Honeywell FRAM announces a new and improved oil filter for Detroit Diesel Series 60 engines:

Effective 7/10/00 we have superseded the FRAM PH7405 to the FRAM PH7405A

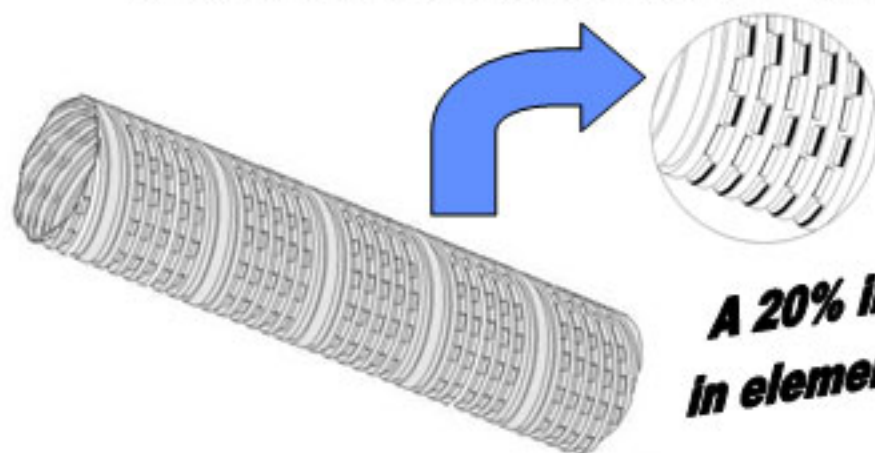
Exclusive new media designed for exceptional capacity, strength with no loss in efficiency

A louvered center tube that insures the highest internal strength while maximizing flow. High flow rates insure even and consistent dirt loading

Centertube Collapse Strength (PSI) Per SAE J806

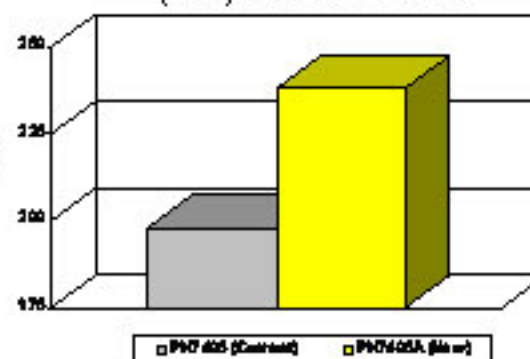
A 20% improvement in element strength!
